**NUCLEAR REACTOR LABORATORY**  
AN INTERDEPARTMENTAL CENTER OF  
MASSACHUSETTS INSTITUTE OF TECHNOLOGY

Subject: Revision to MITR Technical Specifications #7.1 / Reply to Close Out  
Open Item #50-20/2001-202-01

## 7. ADMINISTRATIVE CONTROLS

Fig. 7.1-1 Management Organization

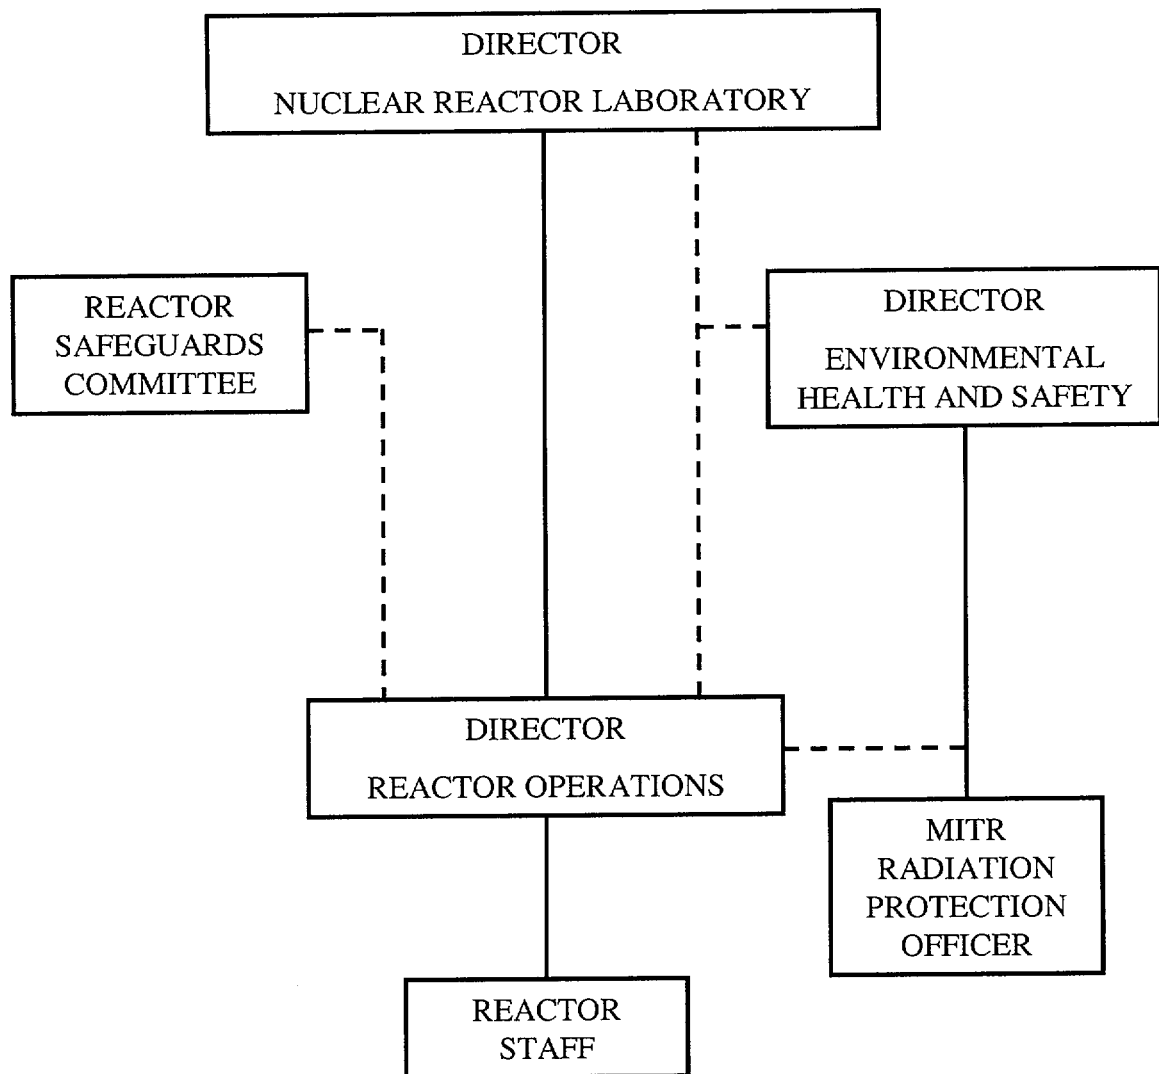
Enclosed is a revision to Massachusetts Institute of Technology Research Reactor Technical Specification #7.1 which reflects changes in the administrative structure at MIT. Please note that submission of this item should close out open item #50-20/2001-202-01 from NRC Inspection Report #50-20/2001-202 dated August 20, 2001.

7.1.2 In all matters pertaining to safe operation of the MIT Reactor (MITR) and to these Technical Specifications, the Director of Reactor Operations shall report to and be directly responsible to the Director of the Nuclear Reactor Laboratory. The management organization is shown in Figure 7.1-1.
